REVIEW OF DETERMINATION ASSESSMENT REPORT

Application Number:	REV2018/0018	
	,	
Responsible Officer:	Thomas Prosser	
Land to be developed (Address):	Lot B DP 404022, 61 Cutler Road CLONTARF NSW 2093	
Proposed Development:	Review of Determination of Application DA2017/1300 for demolition and construction of a new dwelling house	
Zoning:	Manly LEP2013 - Land zoned R2 Low Density Residential	
Development Permissible:	Yes	
Existing Use Rights:	No	
Consent Authority:	Northern Beaches Council	
Delegation Level:	DDP	
Land and Environment Court Action:	: No	
Owner:	Frank Jeremy Hopson Jessica Hee Jin Jun	
Applicant:	Jessica Hee Jin Jun	
Application lodged:	17/09/2018	
Integrated Development:	No	
Designated Development:	No	
State Reporting Category:	Refer to Development Application	
Notified:	21/09/2018 to 09/10/2018	
Advertised:	Not Advertised	
Submissions Received:	5	
Recommendation:	Refusal	
Estimated Cost of Works:	\$ 945,450.00

Photo 1: Taken from the first floor balcony (adjoining living room) of 57 Cutler Road

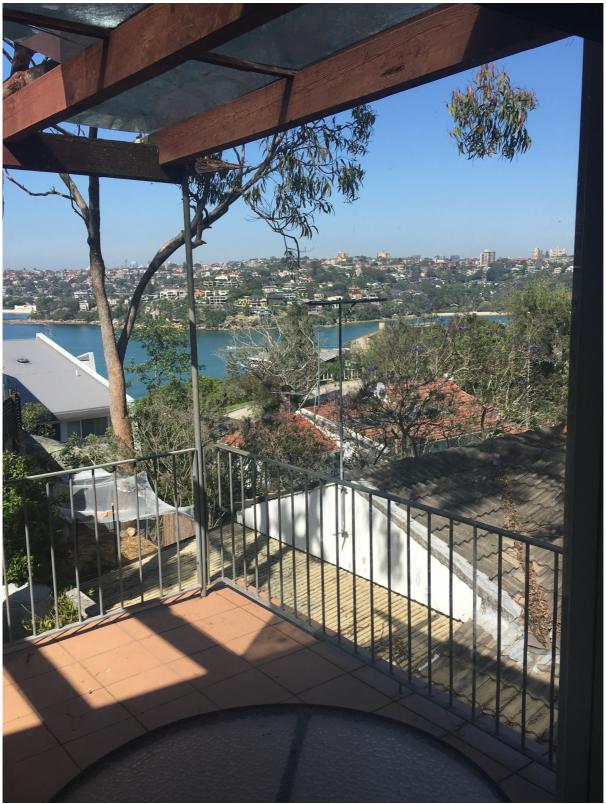
The views that will be affected from this property are water views of Middle Harbour to the southwest filtered by the existing vegetation and residential dwellings. The proposed dwelling height would be close to the land-water interface from a standing eye level and as a result, the land-water interface would be lost from sitting position at parts of the living areas (see Photo 1).

the rear would be higher and would provide a greater disruption to the water and land-water interface views than the existing development.
